FIELD SERVICE BULLETIN

FSB Number: LVCCFSB2003-102
Author: Tony Bryan
Date: October 24, 2003
Total No. of Pages: 3
Subject: **GSM Triplets - Side Key Flex Connectivity**
Model Affected: V300
Level of Repair: 2

Diagram 1.0 Adhesive Removal

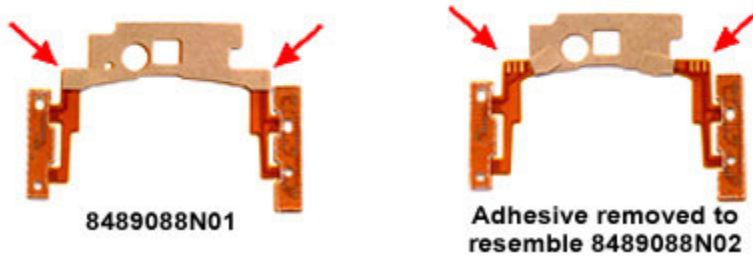
Service is aware of a connectivity issue with the (8489088N01) Side Key Flex on GSM V300. Electrical failures for Side Key-No Function, seen in Factory and ALT Testing, have been linked to a connectivity issue between the Side Key Flex and the contacts on the PCB. The majority of the failures were contributed to the adhesive backed flex.

STEP 1: Manufacturing will be switching over from the current (8489088N01) part to a no-adhesive part (8489088N02) and will modify existing (8489088N01) stock by removing the adhesive at the contacts.

Peel back the tab of the wing to remove the adhesive from the the flex.
Do not cut the tab as this may damage the flex.

1. Modify the adhesive on the side flexes by removing a portion of it.
2. To remove the portion of adhesive from the side flex, peel back the wing of the backing paper and use a black stick to scrape away the adhesive from the area in the picture below.
** DO NOT CUT THE BACKING PAPER OR USE A KNIFE TO REMOVE THE ADHESIVE AS THIS MAY DAMAGE THE FLEX.
3. Afterwards, use an alcohol wipes to thoroughly clean the area of adhesive and debris.
** THIS MODIFICATION SHOULD MAKE THE N01 SIDE FLEX NOW RESEMBLE THE N02 SIDE FLEX.
